**Date: 07/12/2017**  
**Our ref: 2017/4978/PRE**  
**Contact: John Diver**  
**Direct line: 020 7974 6368**  
**Email: [john.diver@camden.gov.uk](mailto:john.diver@camden.gov.uk)**

**Re: 28 Fitzroy Square, London, W1T 6DD**

- 2.1. Advice is requested in relation to the following proposed developments:  
*'Extensions to rear of G11\* listed property at ground floor level; excavation to front lightwell to provide damp proofing and storage; internal alterations from basement to third floor levels; and installation of new AC plant all in association with the continued use of the building as an office (B1a)'*

Figure 1: Diagram showing level of rear development as existing and proposed at nos.26-28

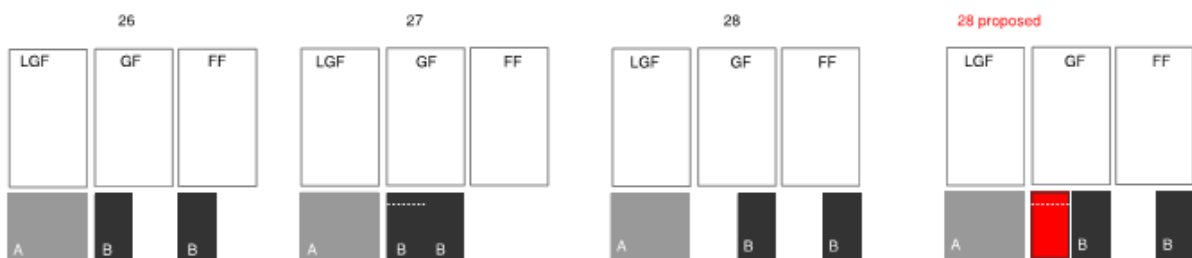
7.20. The main issue at play here is about the acceptability of infilling to the rear courtyard and how this would impact the special interest of the listed building. Each site (nos.26-28) is slightly different but there is a consistent volume/level of infill which has been allowed across each of the sites. The Council has allowed the same amount of infill across each of the adjacent buildings by allowing *either*:

- infilling of the courtyard at ground floor level (above basement); OR
- a two storey (above basement) part width infill extension (Refer to fig 1 below).

7.21. The retention of the first floor part width extension at no. 28 as well as a full width extension at ground floor level would result in more rear infilling than has been allowed on either of the adjoining properties (nos.26/27). As such no direct comparison can be drawn with the scheme hereby proposed and that previously approved to nos.26/27 and it is still considered that the extensions proposed would

unduly overwhelm the courtyard and appreciation from the rear rooms of the building. The Council is being consistent in its decision making process in this regard allowing a similar level of infill across each of the sites and as such retain the objection raised to further infilling at the rear of the site.
